Appendix 5: s53(2)(a) Fast-track Approvals Act 2024 (FTAA) Technical Advice

Date	12/10/2026
To	Consents – Fast-track
Expert Name and Job Title	Philippa Aitchison-Earl, Senior Scientist – Groundwater Resources Science, Canterbury Regional Council
Project advice provided for	Carter Group Limited - Ōhoka Residential Subdivision
Documents referred to	Hydrology Assessment (Bas Veendrick, PDP) Groundwater Assessment of Environmental Effects (AEE) Report (Carl Steffens, PDP) Dewatering and Dust Suppression AEE (Nic Love, PDP)
Qualifications	I hold BSc (Hons) degree in Geology, with a groundwater focused post-graduate dissertation. I am employed at Environment Canterbury as a Senior Scientist – Groundwater and have over 25 years' experience with Canterbury groundwater. I am a member of the NZ Hydrogeological Society. I have published papers in peer-reviewed Scientific Journals, as well as numerous Council reports. My work includes investigating, monitoring, and reporting on groundwater resource quantity and groundwater quality of the region. This role involves assessing and providing advice on potential groundwater impacts of activities seeking consent.

Ōhoka Residential Development – Gr

Figure 1: Schematic hydrogeological cross-section through the Ohoka area (from Sanders and Lovell, 1999)

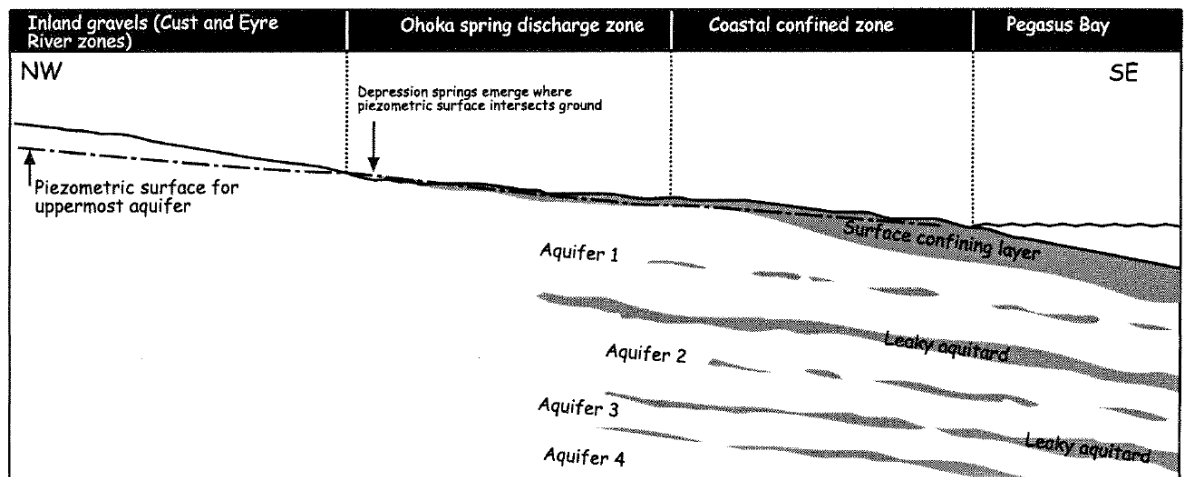
11. I note an additional source of information is available in Sanders and Lovell (1999), a report on the Ohoka Stream during the 1997-1999 drought when the stream was partially dry. This report includes a local piezometric survey to show local groundwater flow direction, which is approximately West to East, broadly similar to regional contours presented in the PDP report. The Sanders and Lovell report also includes additional very low, drought, water levels in well M35/0596 on the site which were added to the ECan Wells Database in August 2025 but are not included in the Hydrology Report (the low water levels are included in Figure 2 in 'Outstanding areas'). These levels are lower than the current well depth, indicating that the well has silted up or partially collapsed.

12. I agree that the springs are likely to be sourced from the water table, where channels are incised into groundwater and through the fine-grained overlying layer. The geotechnical information on the variable thickness of silts overlying the gravel aquifer at the site matches the model from Sanders and Lovell (1999) shown in Figure 1, with springs feeding the Ohoka Stream within a patchy surface confining layer. The mapped springs in Environment Canterbury's database were located in 1996. As

Figure 2: Updated groundwater levels in M35/0596 compared to two other local shallow wells (M35/0601 2.6 km east, M35/0312, 3.5 km north-west and M35/0314 1.9 km north-west). Note less variation in groundwater level post 1999-2000 as Waimakariri Irrigation Scheme starts operation.

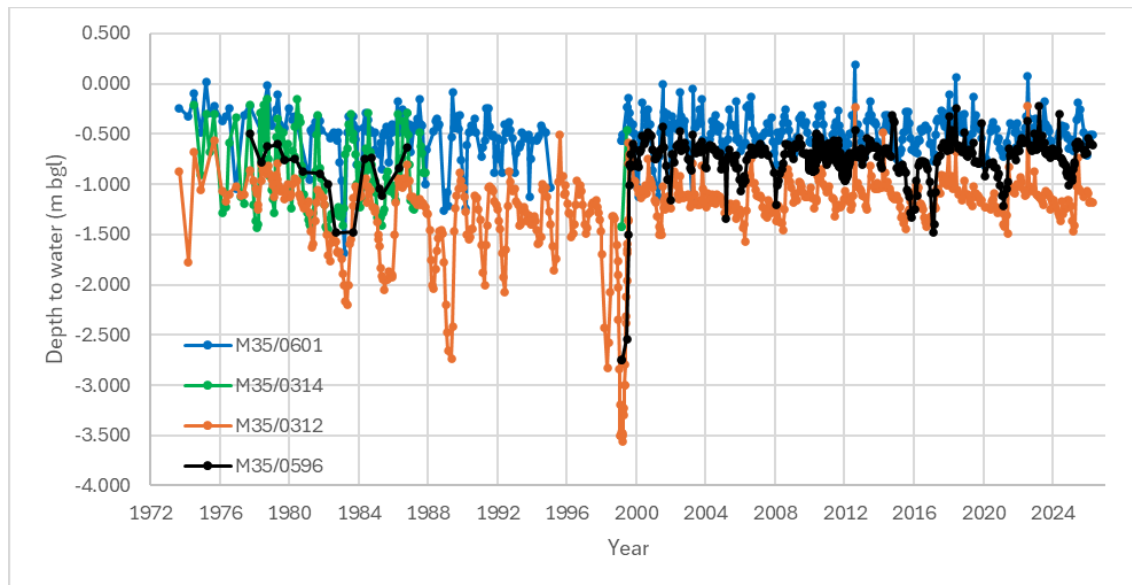
- 37. Depth to water at the site is measured with an array of piezometers. Data from piezometers typically shows highs in May 2025. The long-term data at ECan monitoring well M36/0596 on the site indicates that levels were high between May and August 2025 (as they were regionally). Readings were not reported from all piezometers in June 2025. As this was a wet period it is possible high groundwater may have made access may have been difficult to some sites. If readings were available, they may have shown higher groundwater levels than measured in May.

- 38. Groundwater levels have changed in the area since the Waimakariri Irrigation Scheme began operation from late 1999 and have not reached the very low levels measured in the past. Longer-term groundwater levels in M35/0596, and two local ECan monitoring shallow wells (Figure 2) have not since been as low as measured in and prior to the 1997-99 drought.
